In the Matter of )  
 )  
Part 95, Medical Body Area Network )  
(MBAN) Measurement Procedure )  
 )

GE Healthcare (“GEHC”)<sup>1</sup> hereby submits these comments in response to the October 15, 2015 Draft Publications Report (“Draft Report”) released by the Federal Communications Commission’s (“FCC”) Office of Engineering and Technology (“OET”) Laboratory Division.<sup>2</sup> The Draft Report proposes guidance on the electromagnetic compatibility (“EMC”) and frequency coordination requirements in the FCC’s rules for Medical Body Area Network (“MBAN”) devices.<sup>3</sup>

**Figure 1: RBW = 1 MHz**

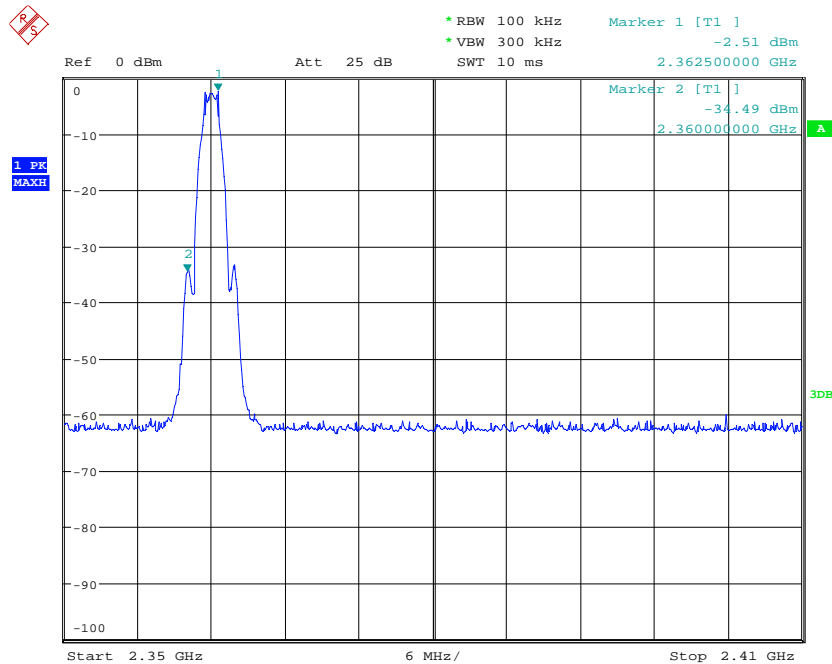
**Section 95.635(d) – RBW Setting.** The Draft Report specifies that the maximum power measured within 2.5 MHz of the 2360-2400 MHz band’s edges (*i.e.*, 2357.5-2360 MHz and 2400-2402.5 MHz) must be at least 20 dB below the maximum power in-band using an RBW equal to 1 MHz.<sup>4</sup> The RBW setting of 1 MHz is likely inappropriate for narrowband MBAN transmissions, such as those with Gaussian frequency-shift keying (“GFSK”) or IEEE 802.15.6 compliant Pi/4-DQPSK modulation, when MBAN sensors operate within 2 MHz of the lower and upper portions of the 2360-2400 MHz band as compared to the out-of-band emissions requirement in Section 15.247(d) of the FCC’s rules, which uses an RBW equal to 100 kHz.<sup>5</sup> The wider RBW captures more energy and results in a 20 dBc limit violation for narrowband MBAN signals at up to 3 MHz away from the 2360-2400 MHz band’s edges (see **Figure 1**). If a 100 kHz RBW were used instead, the measurement sensitivity for detecting spurious energy would be improved, and narrowband MBAN systems would be able to reclaim an additional 2

**Conclusion.** For the reasons discussed above, GEHC proposes the following changes to the Draft Report’s guidance on unwanted radiation measurement: (1) change the RBW setting to 100 kHz; (2) account for RBW filter roll-off in the test equipment specifications; and (3) use 2359.5 MHz and 2400.5 MHz as the center frequencies.

**Figure 2: RBW = 100 kHz**

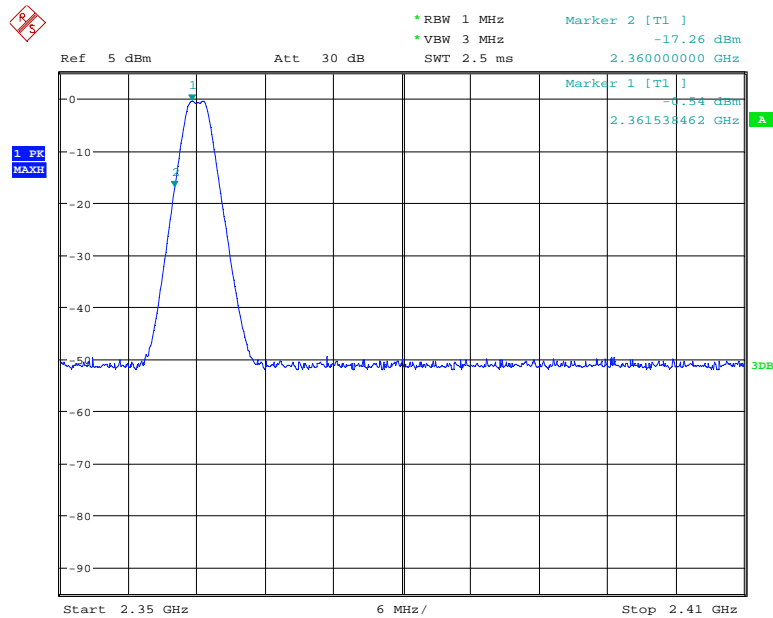
MHz of spectrum for use by operating 1 MHz closer to both edges of the 2360-2400 MHz band  
(see **Figure 2**).

**Figure 3: FSUP Measurement**

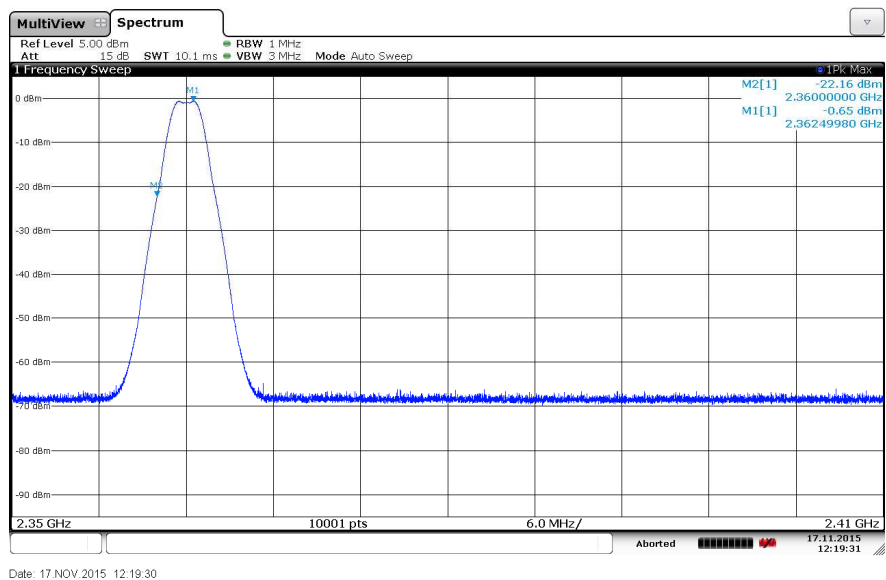
**Section 95.635(d) – Test Equipment Specifications.** The Draft Report’s unwanted radiation measurement guidance should include RBW filter roll-off specifications for the test equipment that perform these measurements. The roll-off for a 1 MHz RBW filter (*i.e.*, shape factor) can vary by several dB across equipment makes and models, which could further affect an MBAN system’s ability to comply with the FCC’s rules. **Figure 3** and **Figure 4** demonstrate a difference of 4.78 dB in two models’ measurements of the same generated MBAN signal.
